RE: 5 Dartmouth Square, Dublin 6

I refer to the above property and to our application under s.5 of the Planning and Development Act 2000 for an exemption in respect of proposed works to our house.

**Re: Section 5 Application for 5 Dartmouth Square, Dublin 6**

**Re: Further Information - Section 5 Application 0354/19 for 5 Dartmouth Square, Dublin 6**

**Partial Site Plan, Front Garden - PROPOSED**

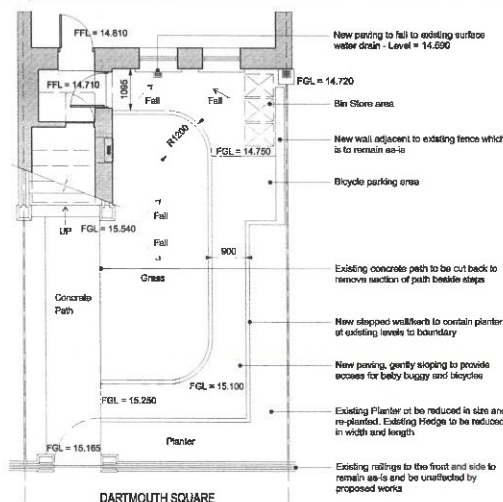
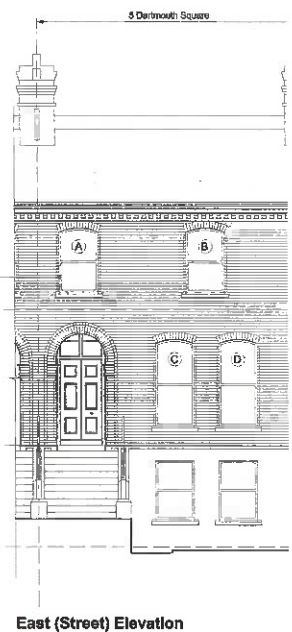
The applicant is requested to provide details on the height/depth/length of the proposed wall along the northern boundary, an elevation drawing showing its height in relation to the front façade of the house and the material to be used in its construction. This information is to include any proposal for a perpendicular wall at its eastern end.

The applicant is requested to provide section drawings showing the alteration to the slope of the garden across both the grass and the new path to assess whether this will have an impact on the protected structure, particularly within the context of the surrounding gardens. These should be dimensioned so that the impact can be fully assessed.

The applicant is requested to submit full details on the colour texture and nature of the material to be used for the path in order for the impact of this on the protected structure to be assessed.

- *Details on the height/depth/length of the proposed wall along the northern boundary* – Heights, depths and length are noted and comprehensively dimensioned on the drawings. Note that the wall is at least 250mm from the existing boundary fence and the top of the wall is no more than 350mm above finished ground level and typically 60mm below the ground level at the boundary.

- *An elevation drawing showing its height in relation to the front facade of the house and the material to be used in its construction* – Sections x-x and y-y on the drawings include elevations that show the proposed low wall in relation to the front facade of the house, and the construction is noted on the Plan

- *This information is to include any proposal for a perpendicular wall at its eastern end* – The wall is only 3380mm long and there's a short return 700mm long at the eastern end and this is 240mm above finished ground level and typically 60mm below the ground level at the boundary.

- *Provide section drawings showing the alteration to the slope of the garden across both the grass and the new path and these should be dimensioned* – Two sections labelled x-x and y-y are provided and both are dimensioned

- *Submit full details on the colour texture and nature of the material to be used for the path* – The Paving material for the path is to be 100 x 100 (Nominal) Granite Setts, natural silver grey colour, with natural split finish

Section X-X & Front Elevation - PROPOSED

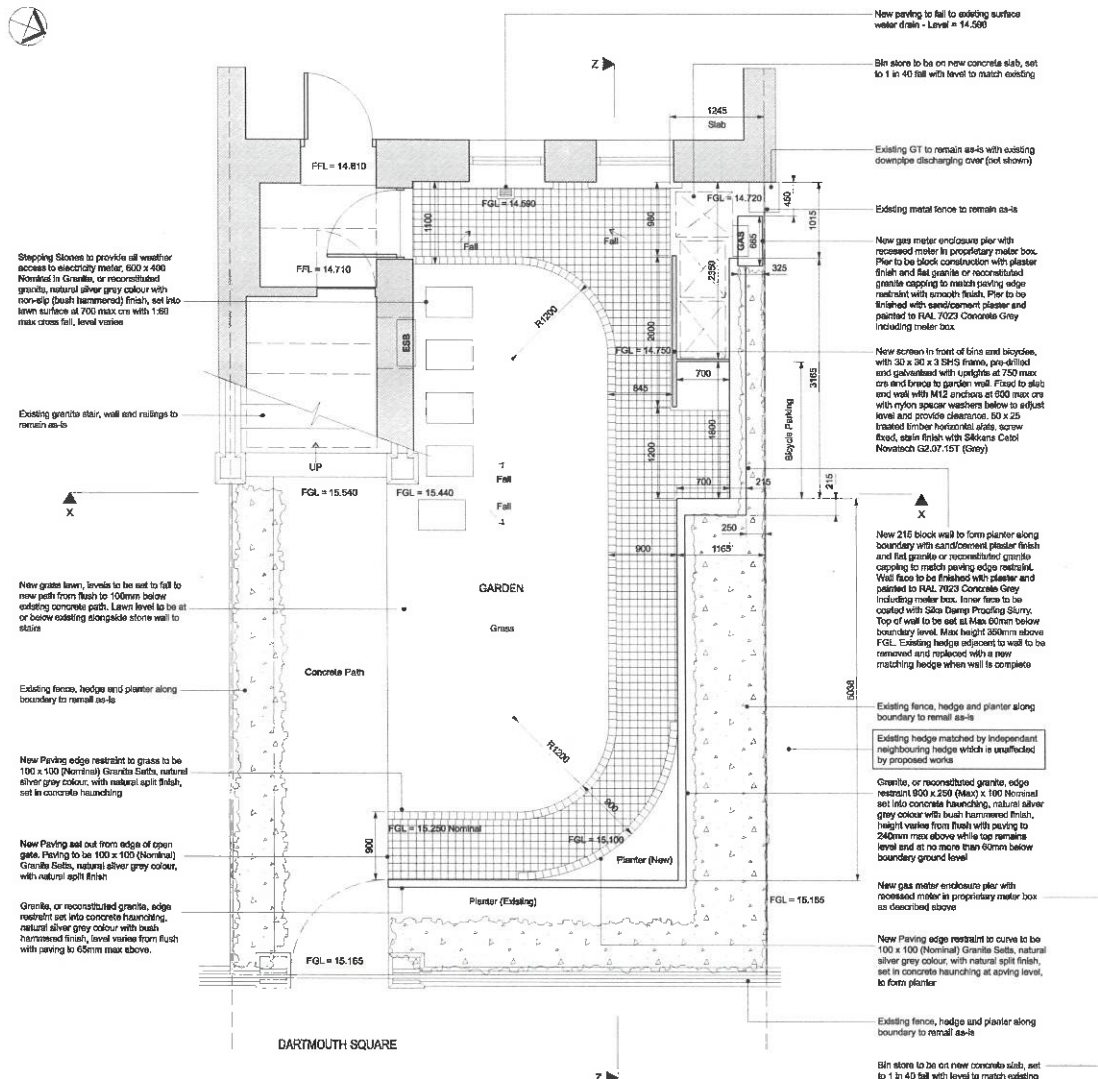
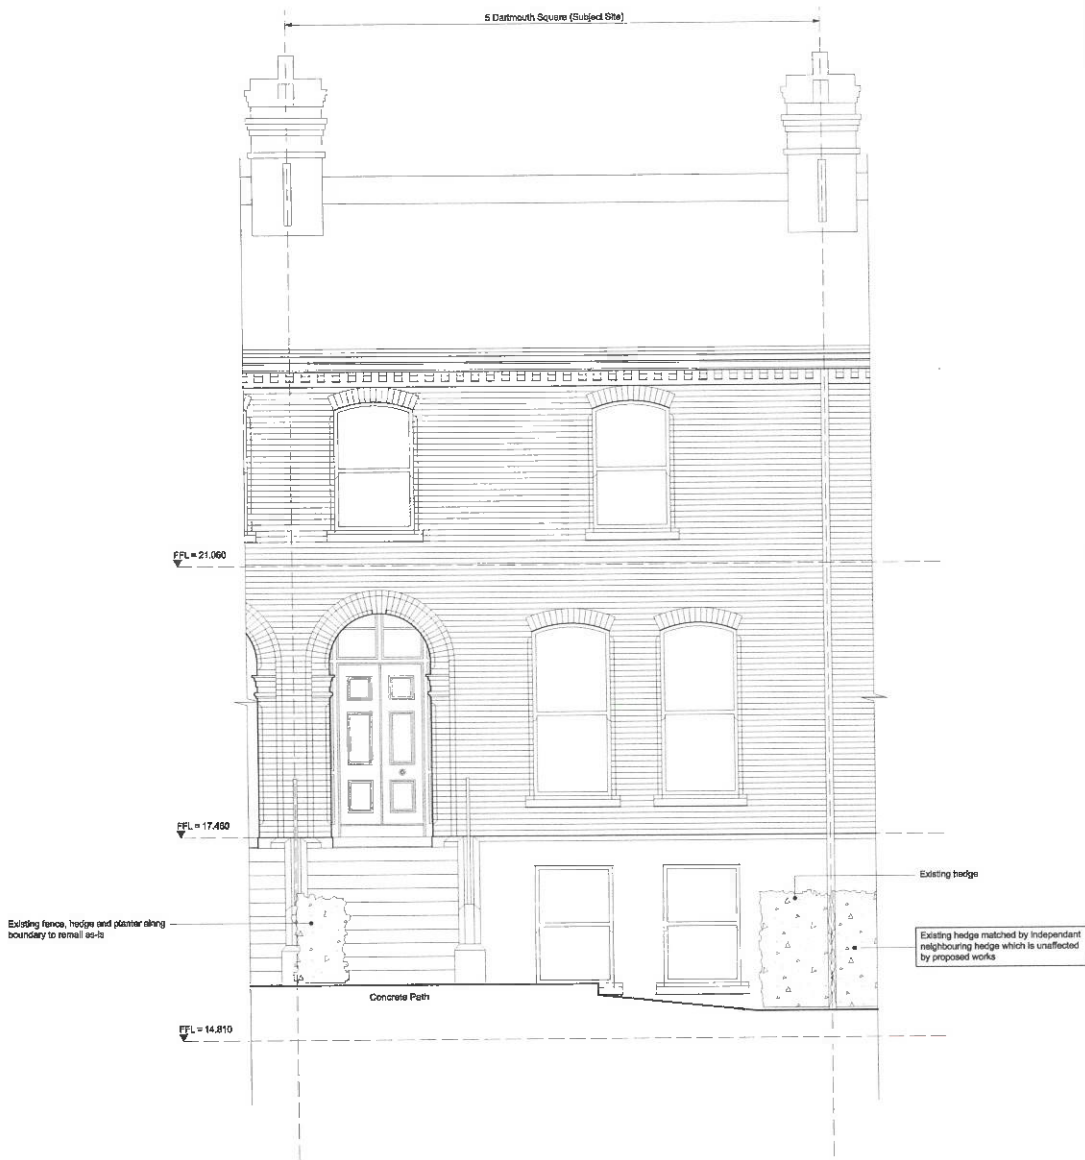
Note: The landscaping works proposed include the provision of a bin store/bicycle storage area, gas meter enclosure, sloping pathway and increased hard landscaping as shown on Drawings 1808-S5-2.1.0 and 1808-S5-2.1.1. The cumulative effect of the proposed interventions to the front garden of the protected structure would materially affect its character and cannot be considered exempted development.

The proposed works comprise development which would not come within the meaning of Section 4(1)(h) and Section 57 of the Planning and Development Act 2000 (as amended) as the proposed development would materially affect the character of the Protected Structure and therefore would require planning permission:

New screen in front of bins and bicycles, with 38 x 50 x 3 S163 frame, pre-cast and galvanneal with uprights at 750 max c/c and brace to garden wall. Fixed to slab and wall with M12 anchors at 600 max c/c with nylon cap nuts washers below to adjust level and provide clearance. 50 x 25 treated timber horizontal slats, screw fixed, stain finish with Sikolara Castol Novosch 02.07.10T (Grey) Climbing, dead to be installed over this

New hedges to match existing. No change to boundary ground level and fence to remain as-is

New 215 block wall to form plaster along boundary with sand/cement plaster finish and flat granite or reconstituted granite coping to match paving edge restraint. Wall face to be finished with plaster and painted to RAL 7002 Concrete Grey including meter box. Inner face to be coated with Silm Damp Proofing Slurry. Top of wall to be set at Max 60mm below boundary level. Max height 350mm above FCL.
